Docket Item # 3
BAR CASE # 2017-00304

BAR Meeting
September 20, 2017

ISSUE: Certificate of Appropriateness for Alterations

LOCATION: 8 Potomac Court

SIDE ELEVATION: PROPOSED

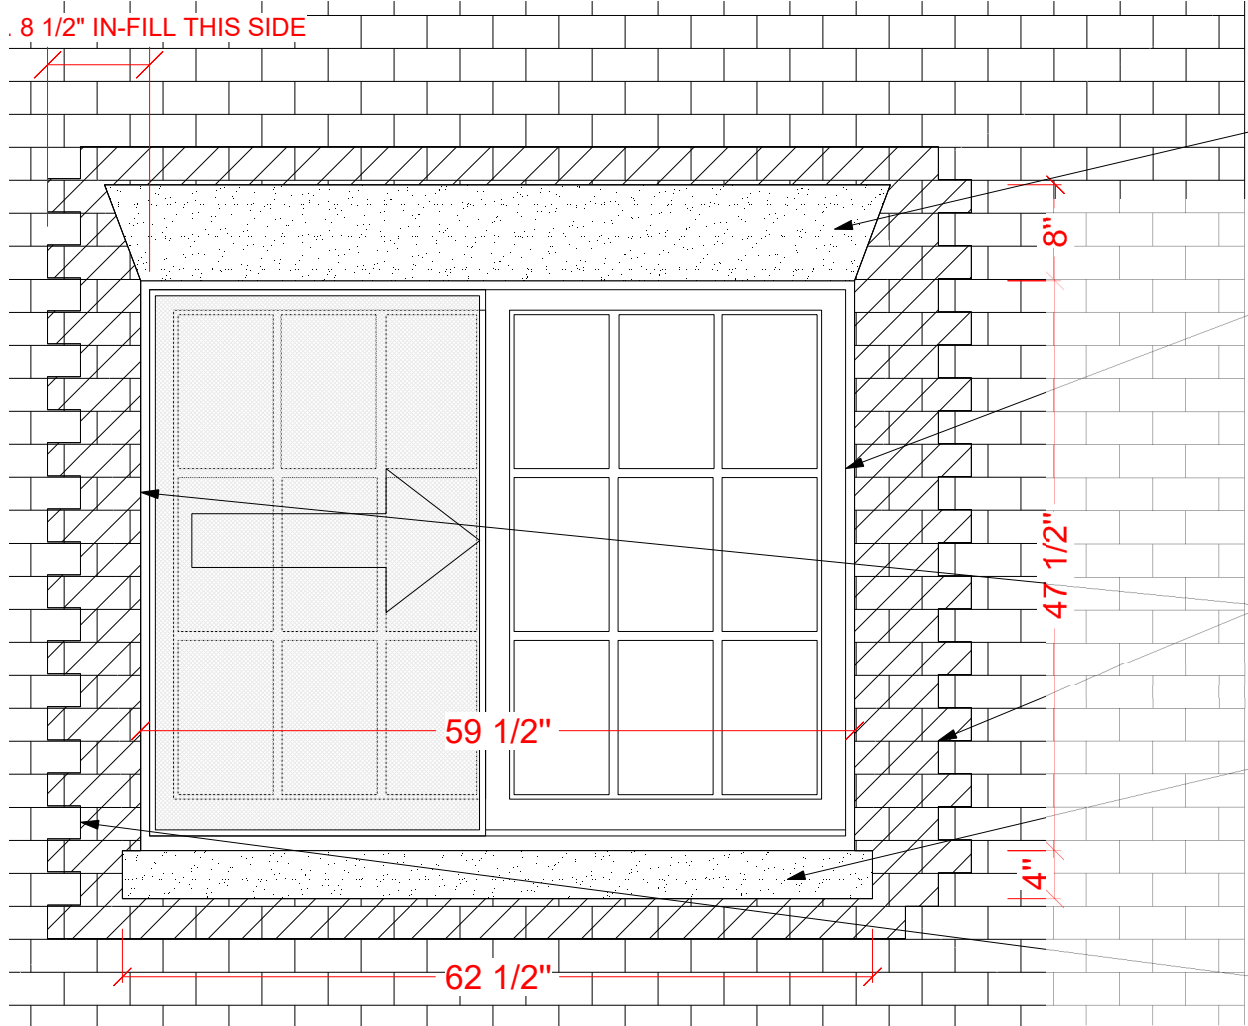
The applicant is proposing to remove the existing in-swing casement window on the south elevation and replace it with a larger Jeld Wen brand, side-sliding aluminum-clad wood window. In addition to changing the operation of the window, the proposed sliding window sash will have a 9-light configuration, as shown in the manufacturer's quote, not the six light design shown on the side elevation drawing. The new window will be 72"x 42", increasing the window opening to 21 square feet. A new precast lintel and sill is also proposed and will match the existing.

Although side sliding windows were not common on Colonial Revival style buildings, this dwelling is a modern 1960s reproduction and the window will be minimally visible behind the deck railing and trellis, so the operation will not be evident from a public way. Staff believes the proposed window alteration is architecturally appropriate, with the condition that it comply with the Performance Specifications in the Alexandria Boards of Architectural Review *Window Policy*.
